TOWNSHIP OF NUTLEY

August 19, 2025

**Re: Addition/Corner Property
624 Bloomfield Avenue
Block/Lot: 2901/36**

Your request for a permit at the above referenced address, to reconstruct an enclosed porch having a 16'6" setback on the street side yard other and to construct a new addition, having a 25' setback on the street side yard other, and to construct a new second floor addition, having a 11'7" rear yard setback, as shown on the plans prepared by MAR Architecture Engineering dated July 14, 2025, is disapproved for the following reason:

PLOT PLAN
SCALE: 1/8" = 1'-0"

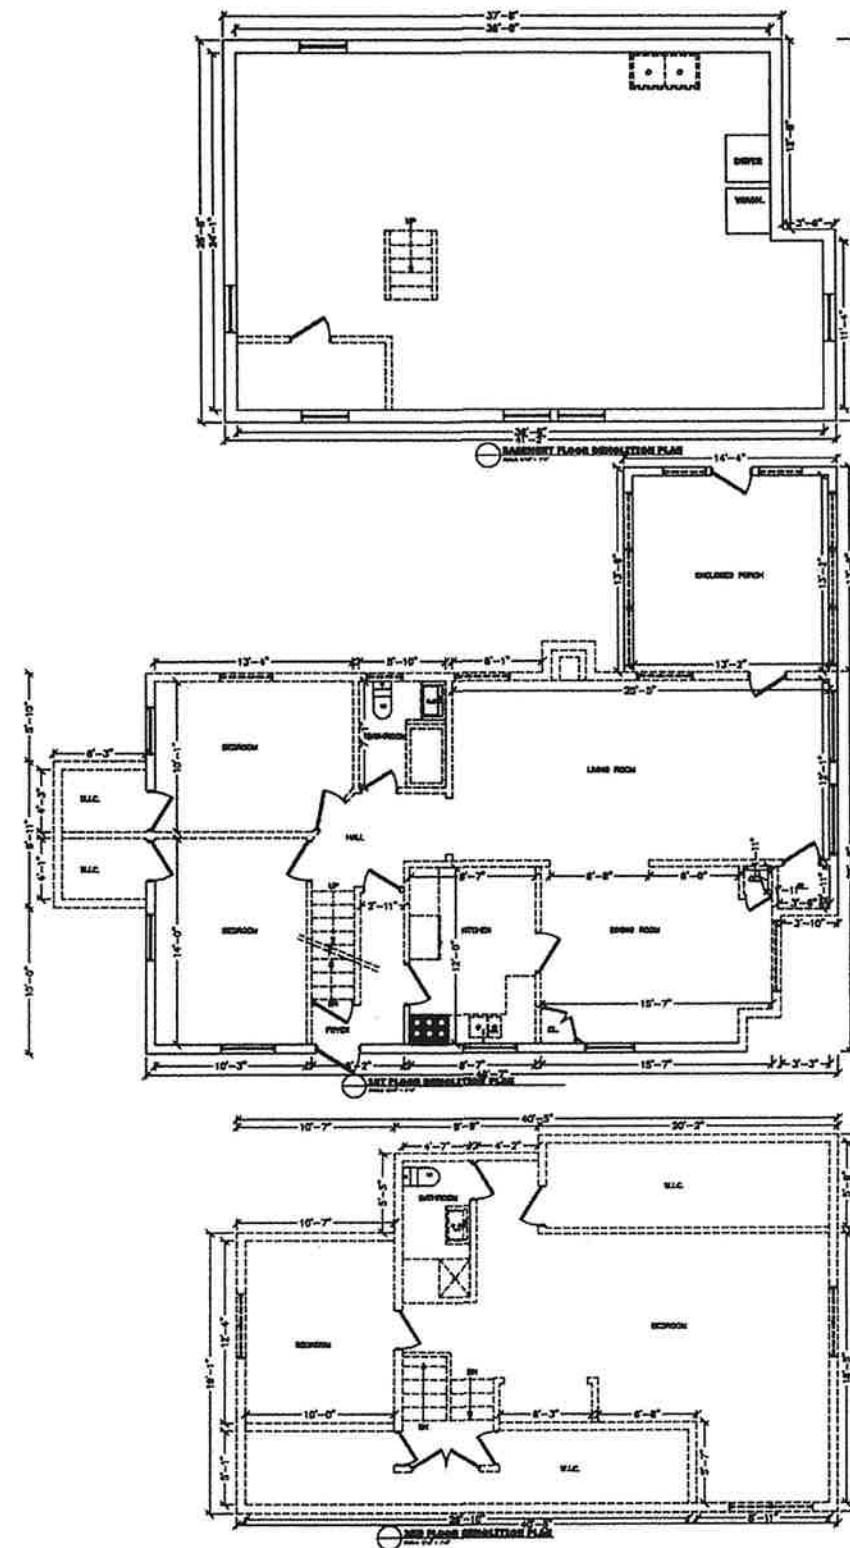
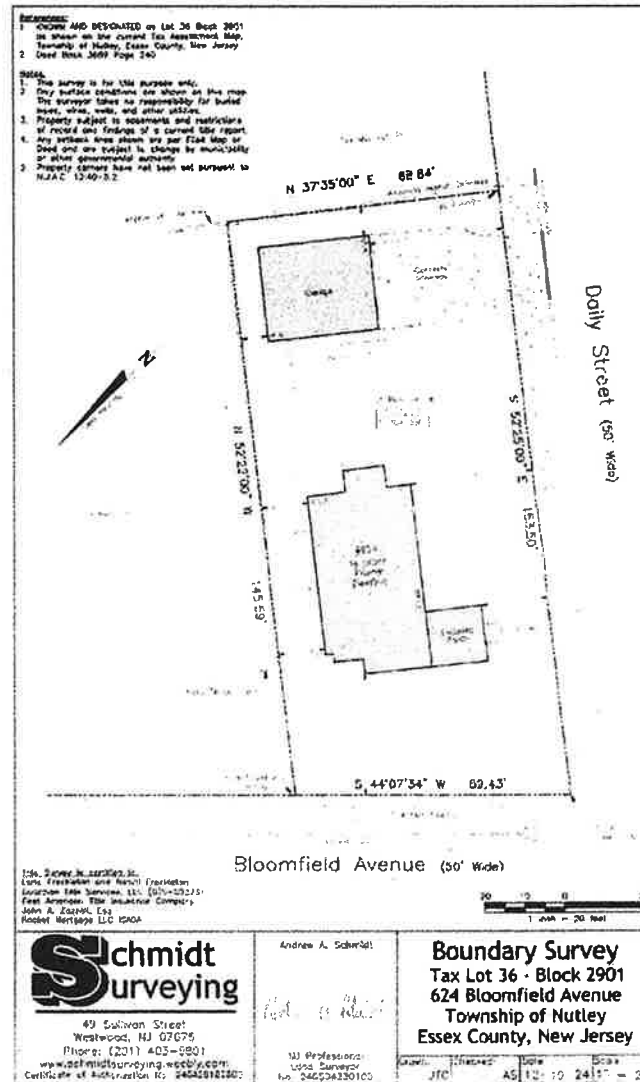
Chapter 700, Article VIII, Section 700-46 B (4) (d) [4] of the Codes of Nutley states the porch shall not exceed a depth of six feet. The height shall be such that the underside of the porch covering is not more than 10 feet above the porch floor.

Chapter 700, Article VIII, Section 700-46 B (4) (d) [5] of the Codes of Nutley states the porch shall not encroach more than six feet into the minimum required front yard for the zone in which it is located. *The average front yard setback is 33.48' feet, the required is 27.48'. The proposed is 16'6" which is the existing footprint.*

Chapter 700, Article VIII, Section 700-46 B (6) (a) of the Codes of Nutley states in the area between two intersecting streets or between an intersecting street and the Township limit or between an intersecting street and a zoning district boundary ("intersecting streets," for the purpose of this section, are those which intersect the same side of the street on which the lot which is to be developed fronts), the depth of the front yard of a lot to be developed in the area shall not be less than the average depth of the front yards of other buildings on the same side of the street, in the same zoning district and having frontage upon the same street, provided that 50% of the frontage of the lots in the same area is developed, but not less than the setback required for the district by the Schedule of Regulations. *The minimum required front yard setback as per the Schedule of Regulations in Section 700-46 A in an R-1A zoning district is 25', the average front yard setback is 33.48' which is the required, the proposed front yard setback is 25'.*

Chapter 700, Article VIII, Section 700-46 A of the Code of Nutley states the Schedule of Regulations requires the following for a rear yard in a R-1A zoning district:

Required
30'

Proposed
11'7"
